Historical Release Report *(Interim Update)*

Response to Comments
for
HRR Annual Updates (1997, 1998, 1999)

**Response to Comments and Meeting Agreements
for the
Historical Release Report (HRR)
PAC Narratives Submitted for No Further Action in 1997, 1998 and 1999**

August 3, 2000

FIGURE 3-2
OUI4-IHSS 156.1
SURFACE-SOIL SAMPLE LOCATIONS

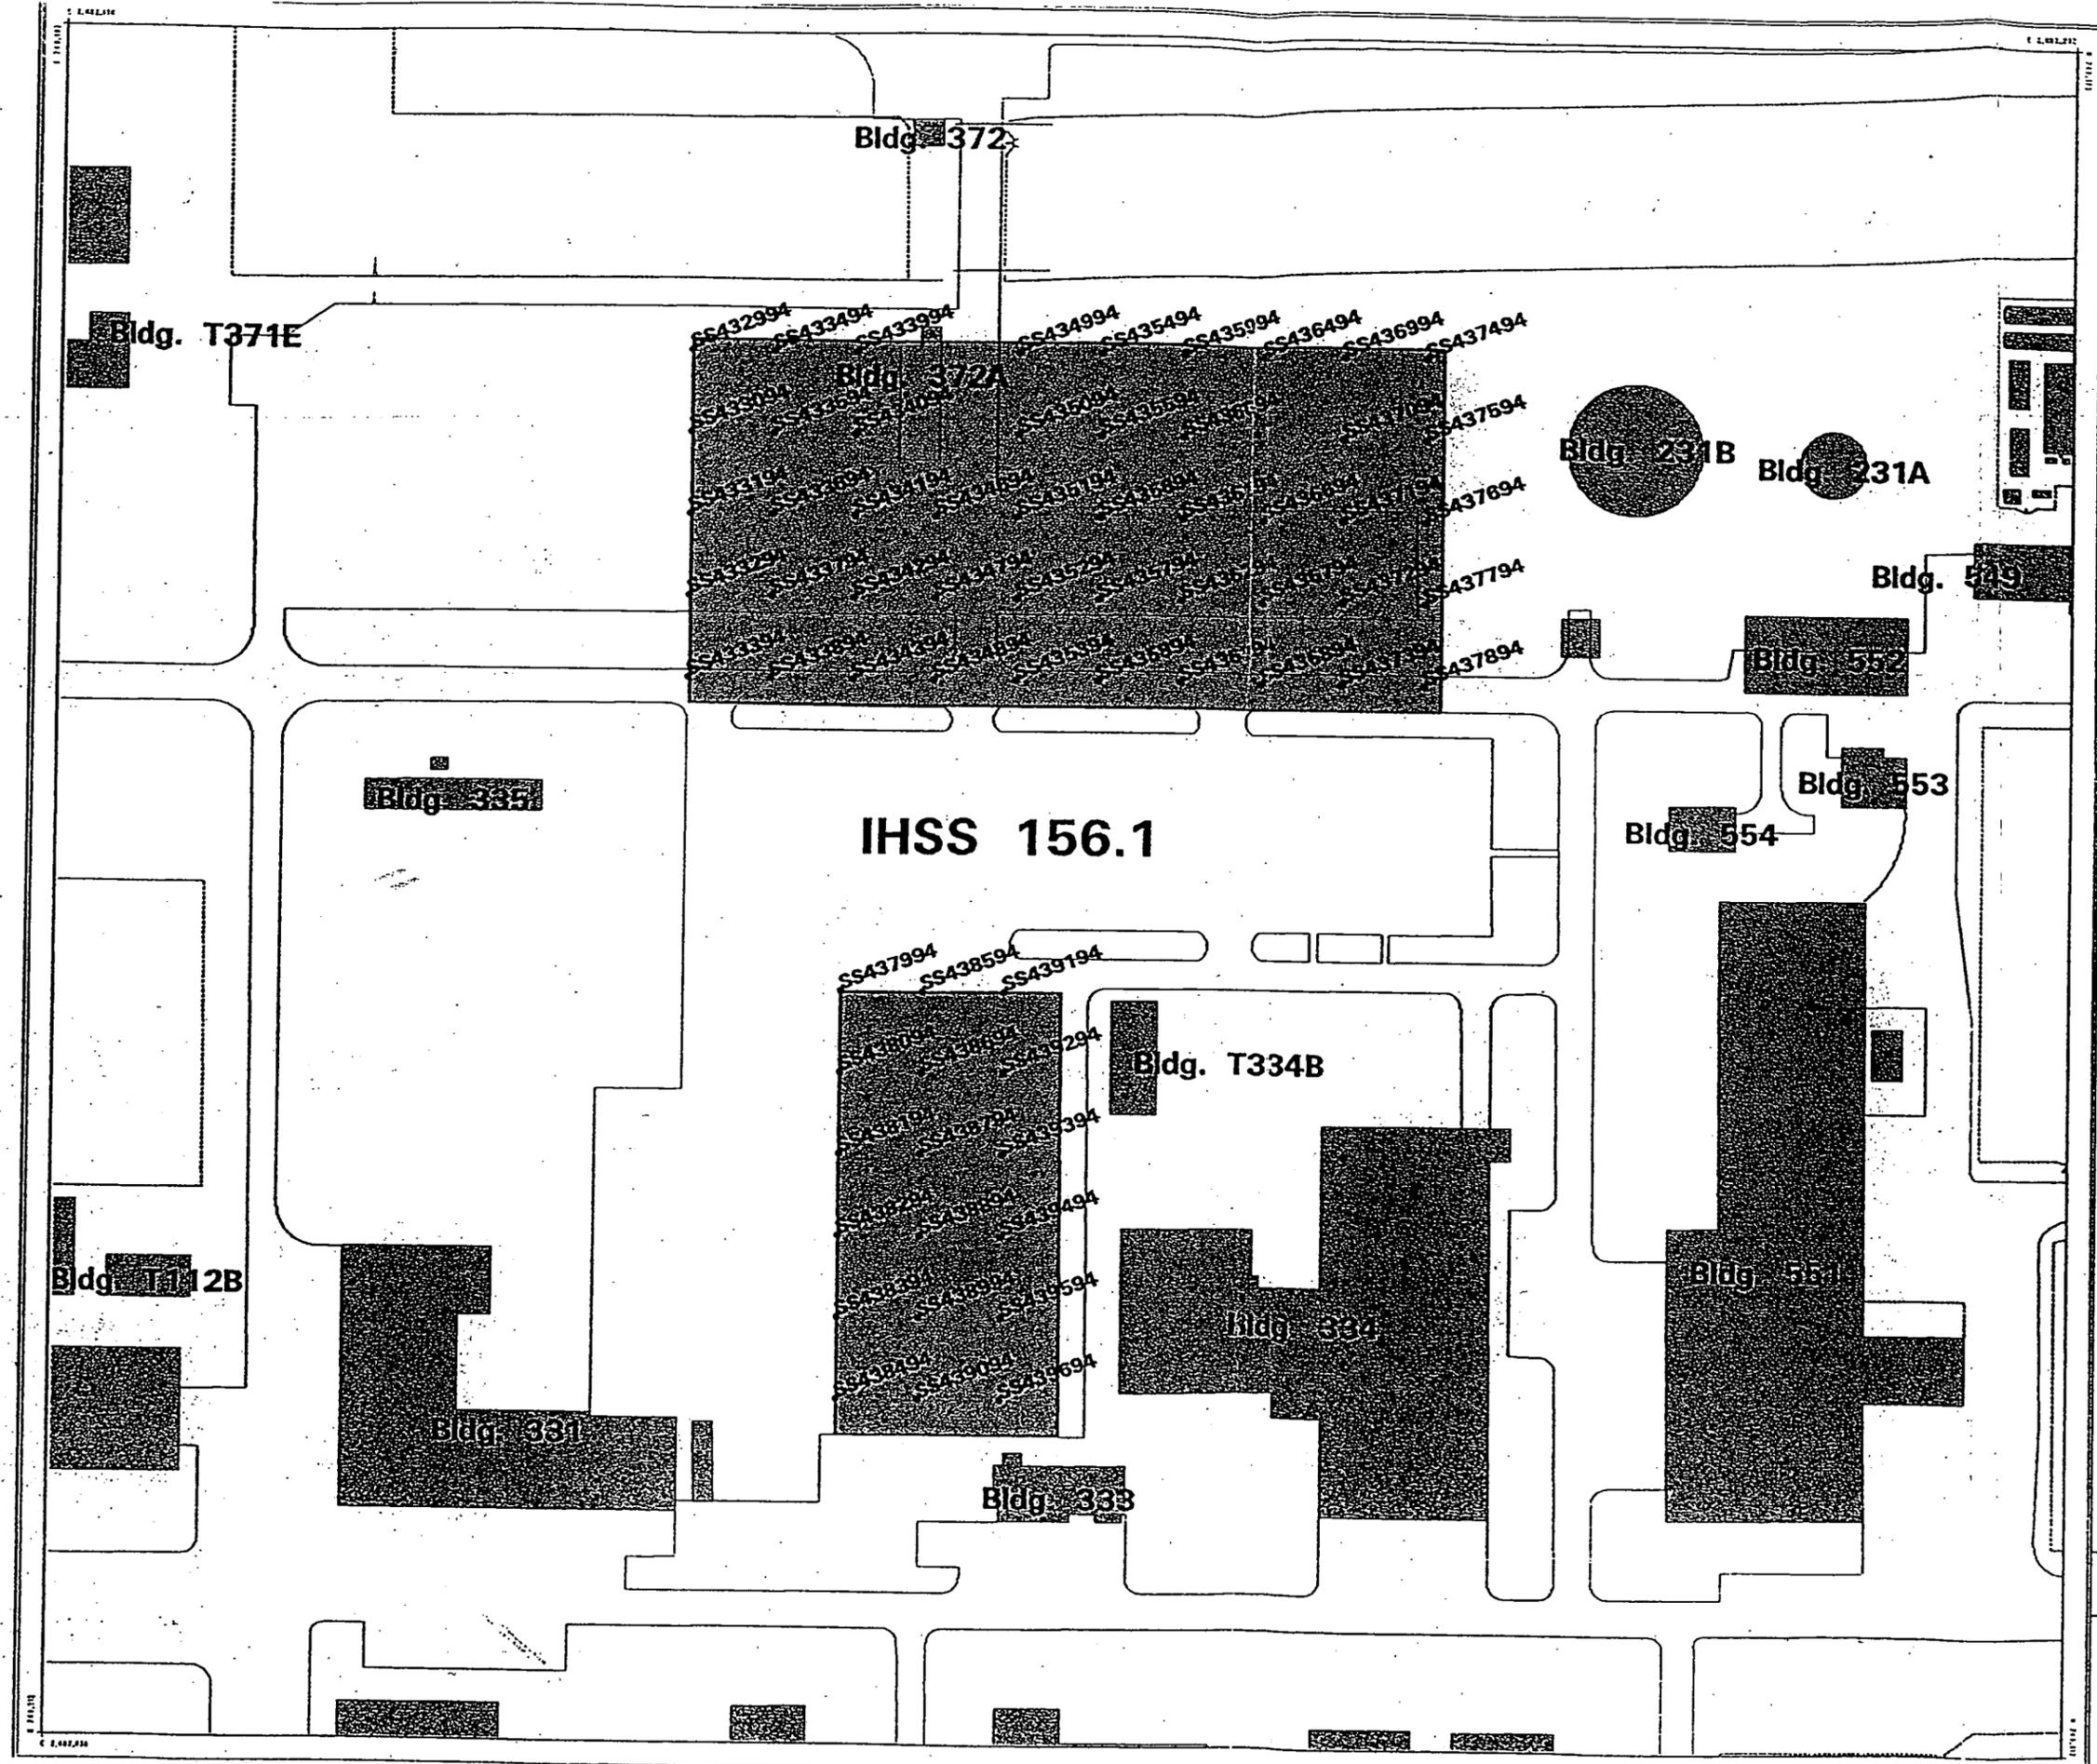
As documented in the Operable Unit 14 RFI/RI Data Summary Report (DOE, 1995), IHSS 156.1 (PAC 300-156.1), which is broken into two separate locations, was sampled extensively in 1995 (see Figure 3-2). Table 1-1 presents the isotopic radiological analysis showing all analysis below RFCA Tier II action levels and at or below established background levels.

During the 1995 study for IHSS 156.1, all analytical data were collected in accordance with an approved workplan and were below established Programmatic Preliminary Remediation Goals (PRGs) for that time. Currently, under RFCA (DOE, 1996), all analysis are below Tier II action levels and further, at or below established background levels for radionuclides. Sampling for IHSS 156.1 was consistent with current comprehensive risk assessment methodologies as agreed upon in a meeting held May 18, 2000 with the Agencies and no source could be identified. Therefore, IHSS 156.1 is proposed for No Further Action based upon comparison of the analytical data to current RFCA action levels.

FIGURE 3-4
OU8-IHSS 123.1
SURFACE-SOIL ANALYTICAL
RESULTS FOR INORGANICS

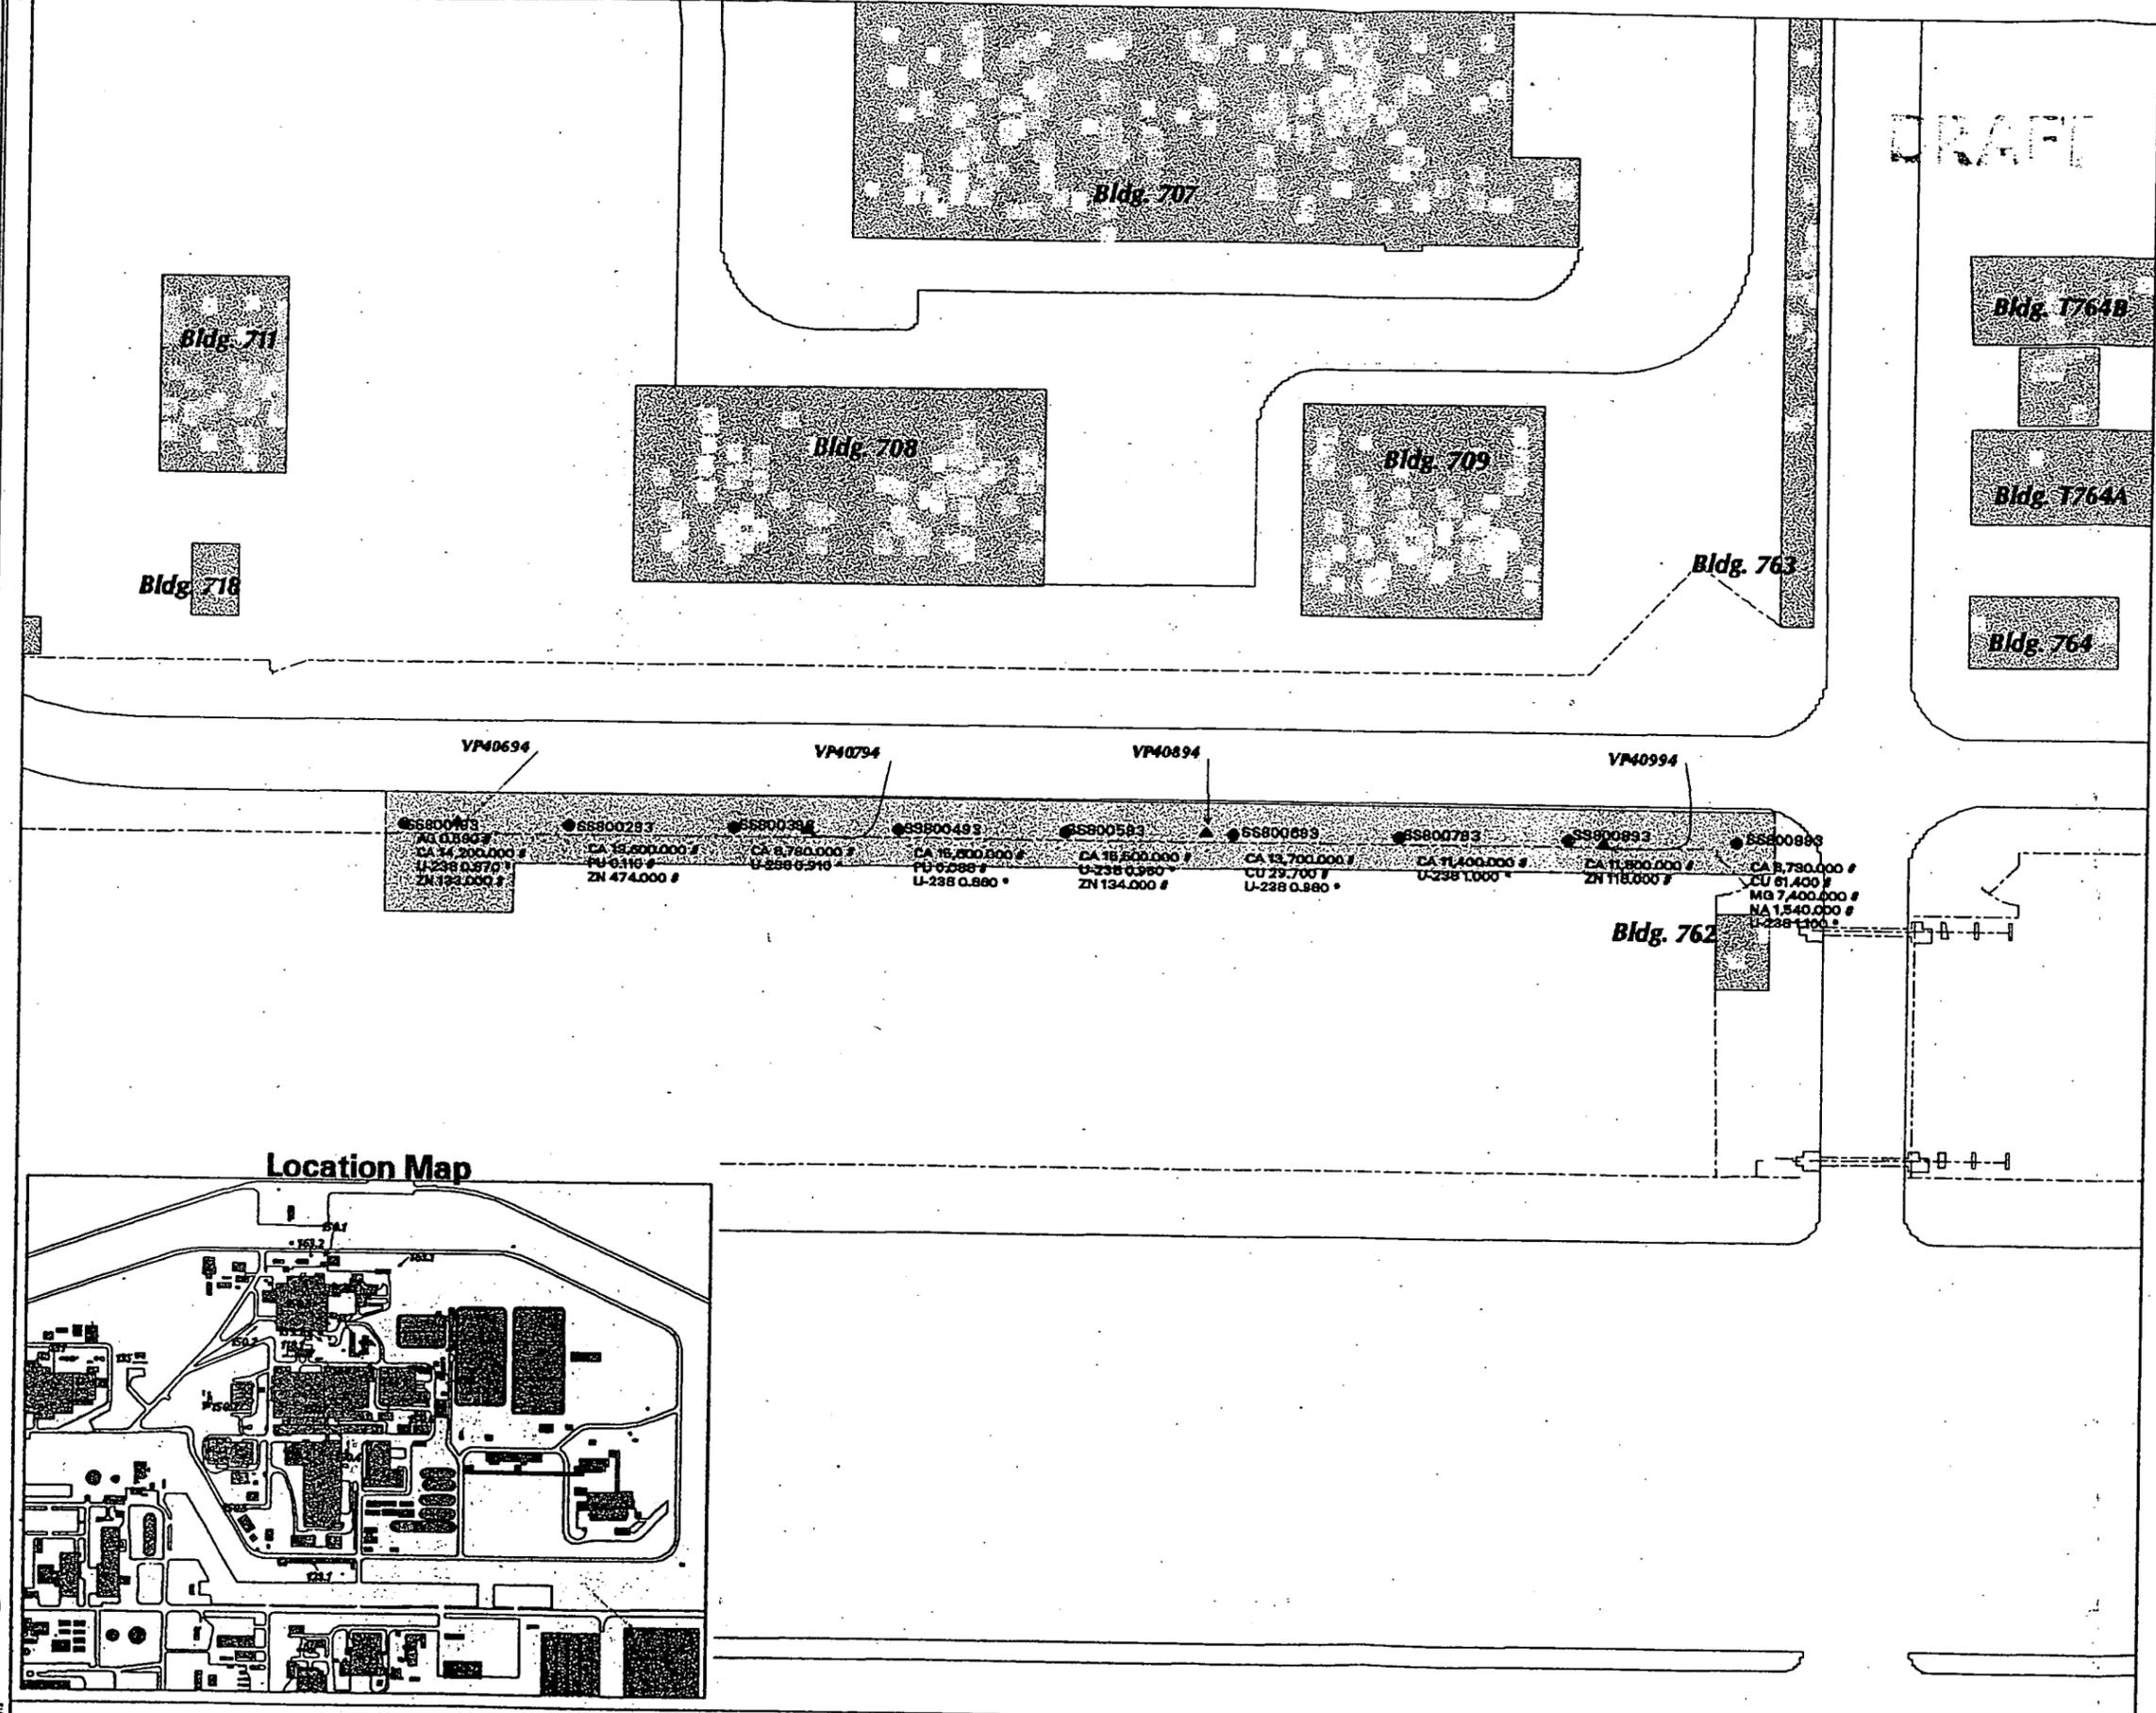
IHSS 123.1 (PAC 700-123.1) was studied in accordance with the IAG schedule for Operable Unit 8. As documented in the Operable Unit 8 Data Summary Report (DOE, 1995), IHSS 123.1 was sampled at nine locations (see Figure 3-4 & 3-5) for inorganics, radionuclides, volatile organic compounds, and semi-volatile organic compounds. These data were validated, compared to background concentrations (if applicable), and then compared to soil actions levels presented in Attachment 5 of RFCA. There were no detections with the exception of benzo(a)pyrene which was present in the sample but below the MDL (Table 1-1).

During the 1995 study for IHSS 123.1, all analytical data were collected in accordance with an approved workplan. Currently, all analysis are below RFCA Tier II action levels (DOE, 1996) and at or below established background levels for radionuclides. Sampling methodology for IHSS 123.1 was consistent with current Sampling and Analysis Plans (SAPs) and no current source of contamination could be identified. Therefore, IHSS 123.1 is proposed for No Further Action based upon comparison of the analytical data to current RFCA action levels.
